# Technical Repercussion Sheet

| A350-XWB | <b>L26118</b> | STATUS: OFFICIAL(Full TRS) |

| <b>TITLE:</b><br>E.a.E. - Cable Loom Inst. drawings - Modify harnesses installation for OHSC in Door Zone D3<br>LH FWD (sol. G) | <b>ATA:</b> 9280                      |

| <b>GENERAL DESCRIPTION:</b><br><br>The modification consists in modifying harnesses installation for OHSC in Door Zone D3 LH FWD (sol. G)<br><br><b><u>Abbreviations</u></b><br>OHSC : overhead stowage compartment<br>D3: door 3<br>LH: left hand<br>FWD: forward<br>Sol.: solution |

## SECTION 15/21 SKETCHES

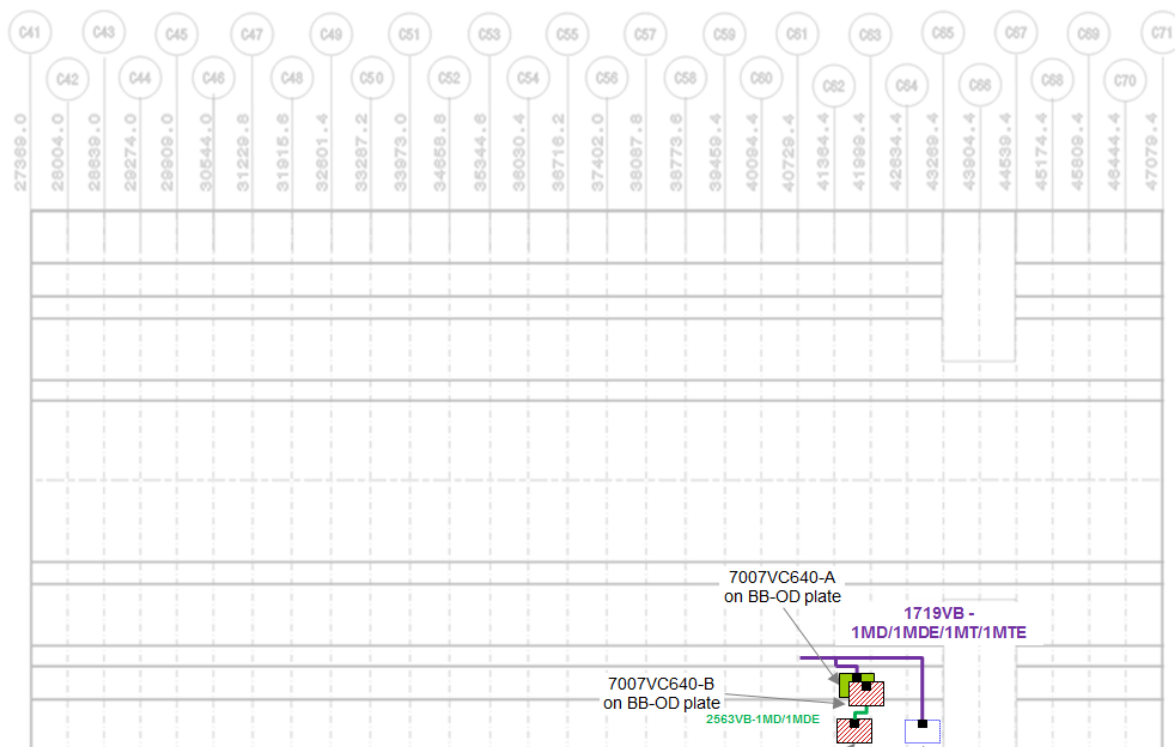
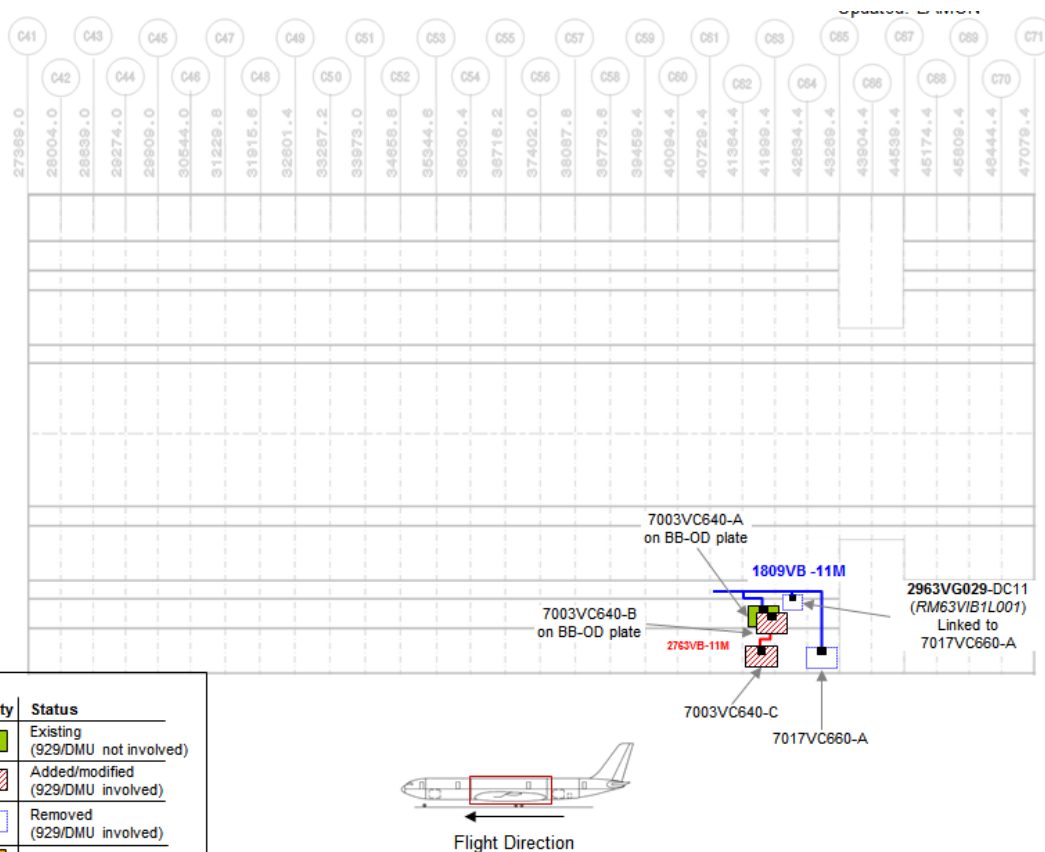
E.a.E. - Cable Loom  
Inst. drawings - Modify  
harnesses installation  
for OHSC in Door  
Zone D3 LH FWD  
(sol. G)

**Post-MOD sketch:**  
E.a.E. - Cable Loom  
Inst. drawings - Modify  
harnesses installation  
for OHSC in Door  
Zone D3 LH FWD  
(sol. G)

Sketch CEF ESI HAR EQT 1

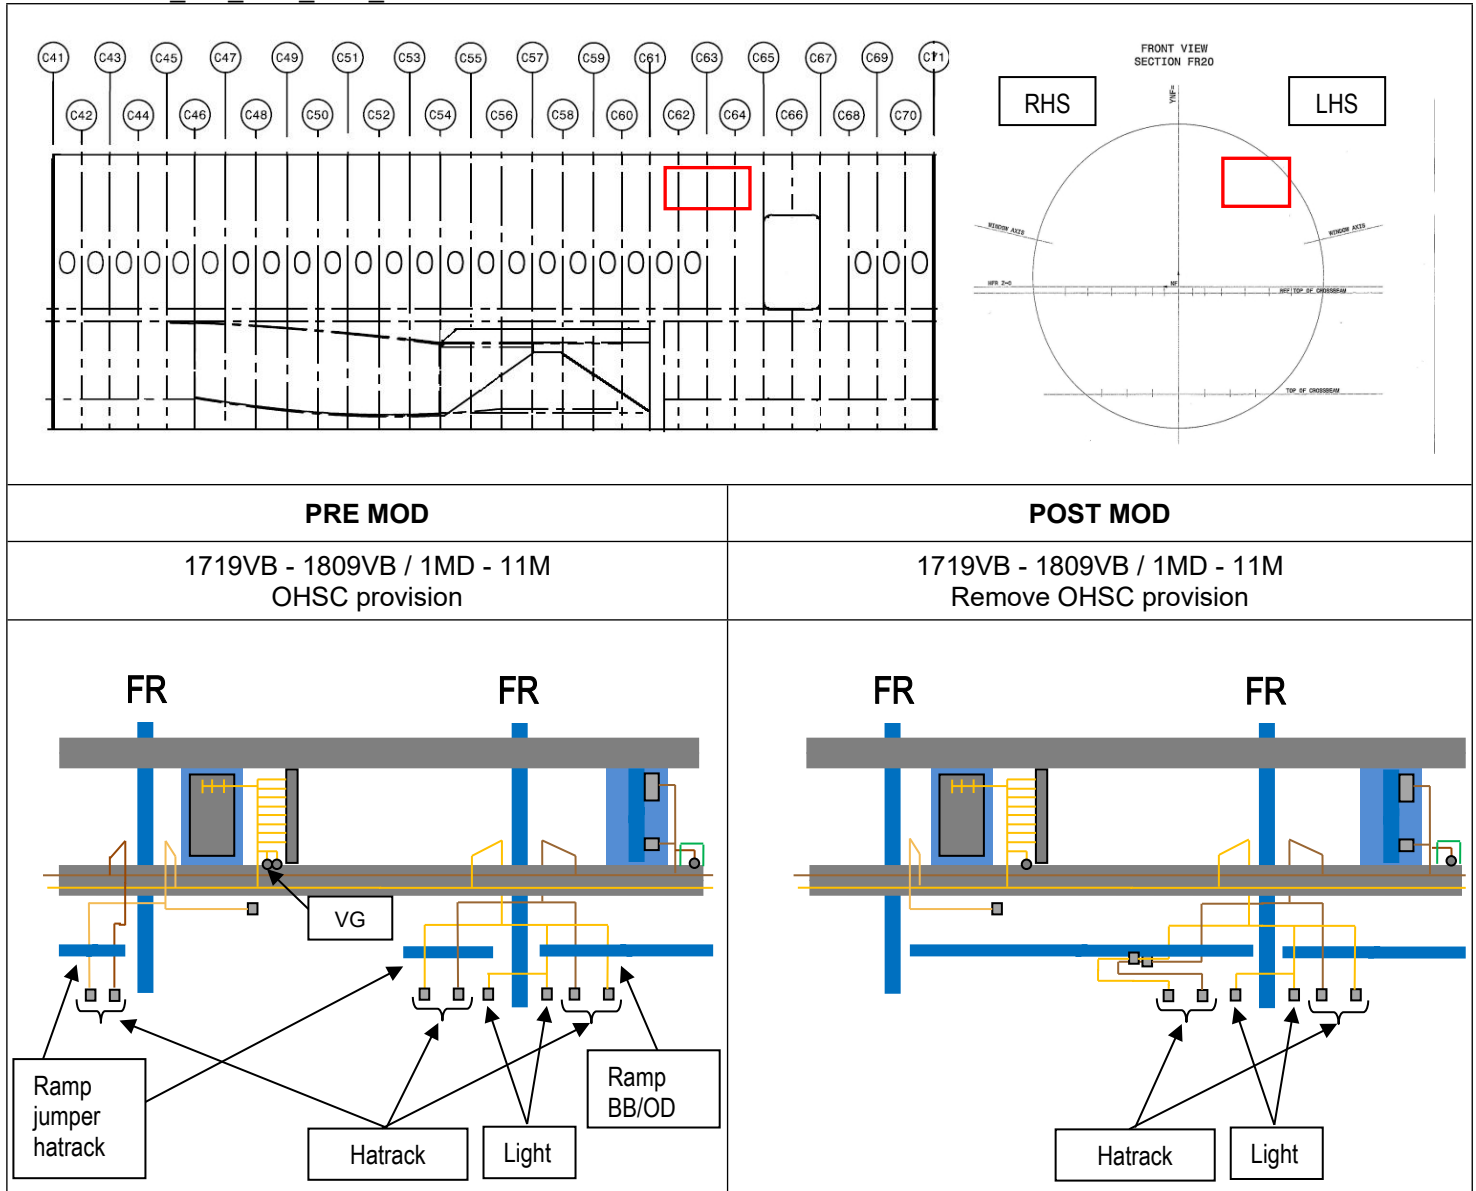
Modify installation as shown in Sketch CEF\_ESI\_HAR\_EQT\_1:

CEF UD MLH MD/M CTAFT: To remove 3 clips nut between FR62 and FR63.

To relocate 4 clamps between FR62 and FR63.

CEF UD MLH MD/M AFT: To remove 9 clamps + 4 spacers + 1 clip nut between FR63 and FR64.

CEF UD Z5-6 MLH HAT: To add 8 clamps + 8 spacers between FR62 and FR64.

Modify installation as shown in Sketch CEF\_ESI\_HAR\_EQT\_1:

Harness 1809VB 11M  
Harness 1719VB 1MD  
Harness 2763VB 11M  
Harness 2563VB 1MD
